MILWAUKIE PLANNING COMMISSION Tuesday, June 25, 2013, 6:30 PM

- 5.0 Public Hearings** – Public hearings will follow the procedure listed on reverse
 - 5.1 Summary: Setback Variance
Applicant/Owner: Ron Woodruff/Perry Nordby
Address: 9925 SE 37th Ave
File: VR-12-05
Staff: Li Alligood

File: Variance, VR-12-05
Site: 9925 SE 37th Ave, Milwaukie, OR 97206
Re: Revised Incompleteness Letter

Re: Response to May 23 clarification of Type III Appeal info.

(B-B) GAR WALL/COOK TOP
ELEVATION/SECTION
1/4" SCALE 3/26/13
(PATIO COVERING)
EXHIBIT #10

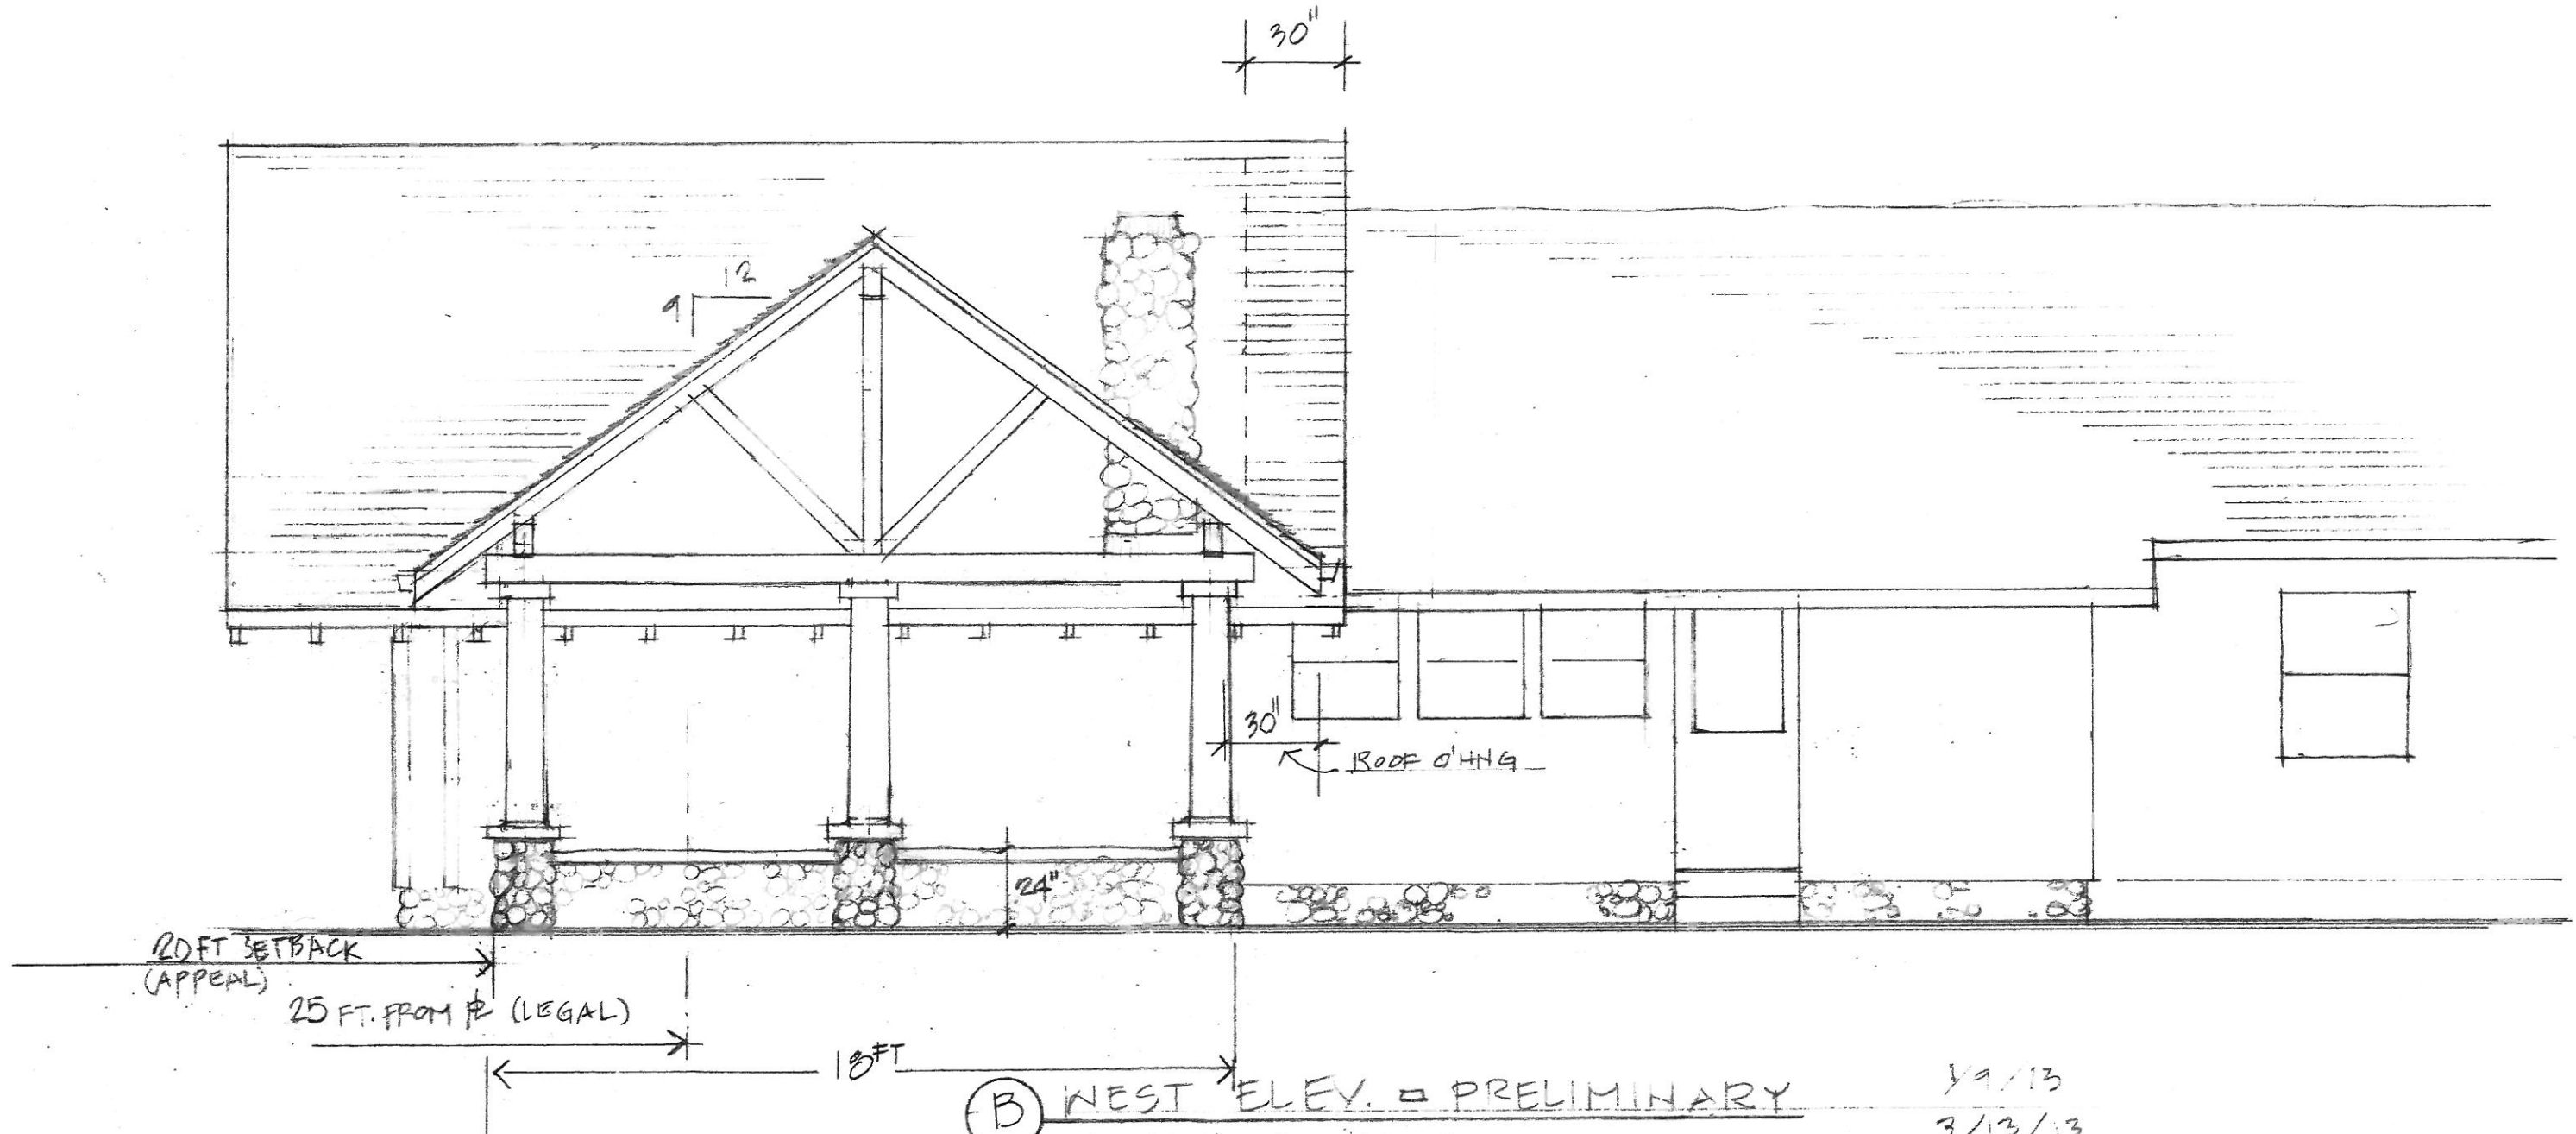
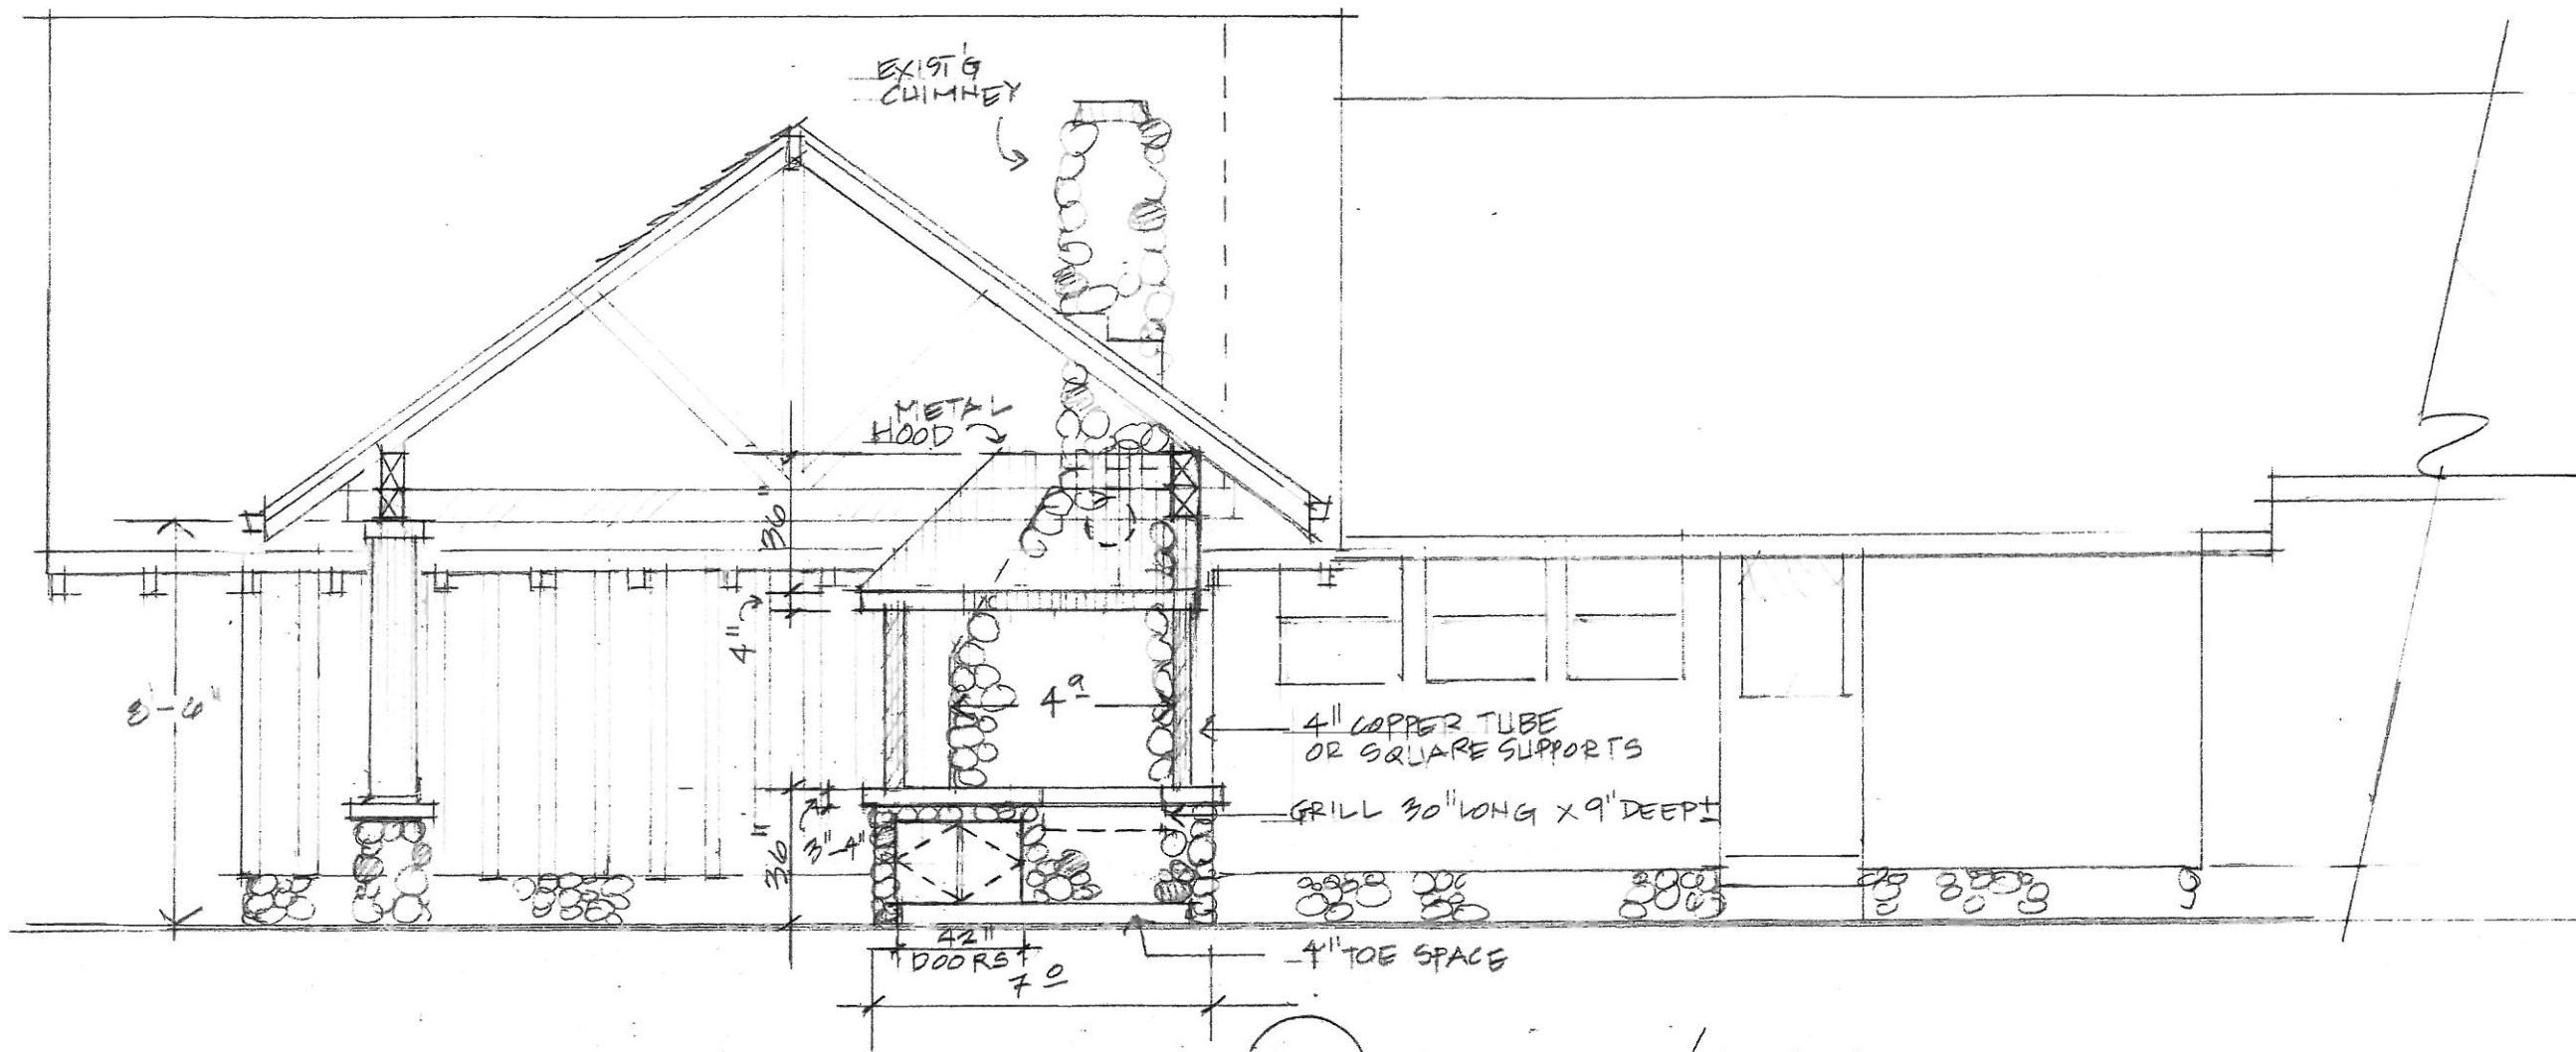
Request #3: Provide a patio covering open on three sides west of the existing garage, request setback at side (Harvey St.) at 20 ft. and rear yard setback of 18 ft. (See "Site Plan - Request #3" and Exhibits #9 through #12)

ANSWER: Impacts on side yard (Harvey St. side) would be minimal due to the fence obscuring view of the addition as well as being below grade at street level further obscuring any view of new structure which might obviate any potential visual impacts.

ANSWER: The existing fence to the north may work to obscure any potential negative impacts (see elevation Exhibits # 9 – 12). Exhibit #9 shows Harvey St. elevation
